SERVICE BULLETIN REVISION TRANSMITTAL SHEET

MODEL BD-700-1A10 (BD-700)

Service Bulletin No. 700-27-050
Date of Basic Issue Jul 02/2007
Revision No. 01 Dated Jul 03/2007

**MODIFICATION – CONTROL AND INDICATION SYSTEMS –
 SLAT/FLAP CONTROL UNIT (SFCU) UPGRADE TO PART NO. GT415-5900-15**

Reference of Torque Tube Initial Position
Figure 1

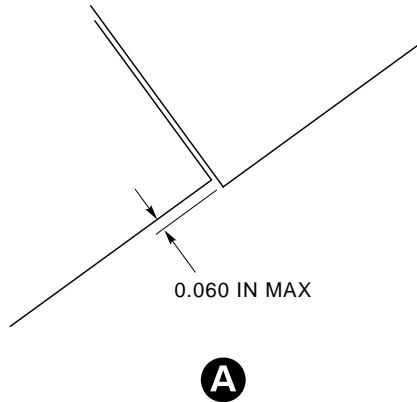
- (6) Do the rigging of the slat system as follows:
 - (a) In the CAIMS PMAT, do as follows:
 - (i) Go to SYSTEM DIAG to get ATA SELECTION DISPLAY page (1/2).
 - (ii) Go to ATA 27-00 FLIGHT CONTROLS to get the LRU SELECTION PAGE.
 - (iii) Go to SLAT/FLAP CONTROL UNIT #1 to get the STORED FAULTS DISPLAY/LRU TEST page.
 - (iv) Go to LRU TEST to get the SFCU 1 LRU TEST MENU 1/1.
 - (v) Go to SLAT RIGGING – SFCU 1 to get the SFCU 1 SLAT RIGGING – PAGE 1/4 screen.
 - (vi) Go to CONFIRM to get the SFCU 1 SLAT RIGGING – PAGE 2/4 screen.
 - (vii) Go to SLAT RIG ENABLE COMMAND and push SELECT.
 - (viii) The indications LEFT/RIGHT SLAT RESOLVER (DEG) should show 20.0 ± 10.0 degrees.
 - (b) Put reference marks on the left hand or right hand torque tube and on the adjacent pad to record the initial position of the torque tube. Refer to Figure 1.

- (v) Go to RELEASE R SLAT MOTOR BRAKE.
 - (vi) Go to SELECT.
 - (vii) Go to RELEASE L SLAT MOTOR BRAKE.
 - (viii) Go to SELECT.
- (d) Retract the slats panels by manually rotating the torque tube until you reach the mechanical stop and record the number of turns required. Refer to Figure 1 for rotation direction.

Put a reference mark on the torque tube (1) and on the adjacent pad (2).

Steps Measurement
Figure 2

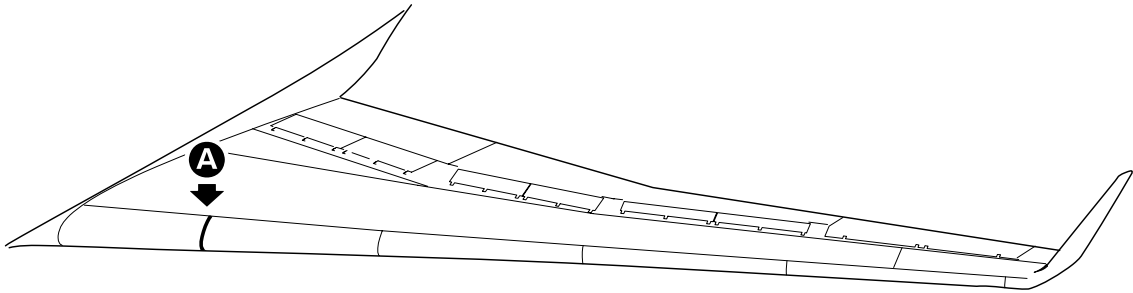
- (f) Measure the step between the leading edge of the No. 1 slat panel and the wing fixed leading edge. Refer to Figure 2.
- (g) If the step between the leading edge of the No. 1 slat panel and the wing fixed leading edge is greater than 0.060 in (1.52 mm), do as follows, otherwise go to next step (h):

- (i) Manually rotate the torque tube until the step between each leading edge of the No. 1 slat panel and the wing fixed leading edge is 0.060 in (1.52 mm) or less and record the number of turns required.
